Ferrari North America, Inc.

U.S.A. RECALL CAMPAIGN NO. C24000078

Replacement of brake fluid reservoir cap and updating of Instrument Panel Node (NQS) software

SUBJECT: Recall Campaign No. C24000078

Fig. 2

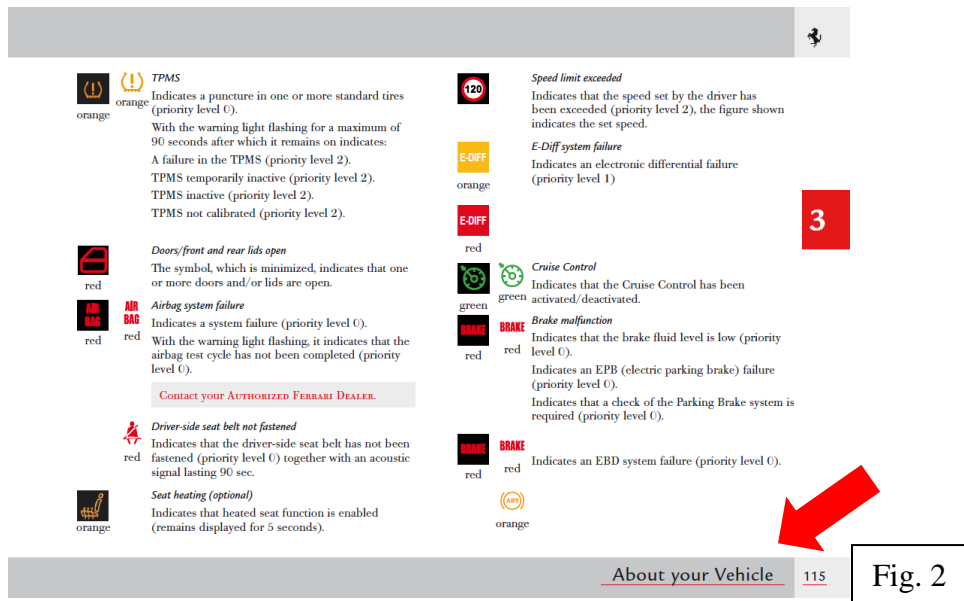
Please find below the proper location and instructions on how to insert the sticker provided into the Owner's Manual (PN: 079641778);

The sticker must be placed in the page shown above in the Owner's Manual. This page is located in the '*About your Vehicle*' section where the warning lights of the instrument panels are described. Please be sure to attach it to the page with the '*Brake Malfunction*' description as shown in Fig. 2

Once you locate the proper page, remove the adhesive protector off of the back of the sticker. Ensure there is no residue or other particles on the page that may inhibit the longevity of adhesion to the page. Place the sticker to allow the bottom of the sticker to lay directly above the gray margin at the bottom of the page that contains the text '*About your Vehicle*'. Once applied, apply pressure across the whole strip of 'glue' to confirm the sticker has been properly mated to the page.
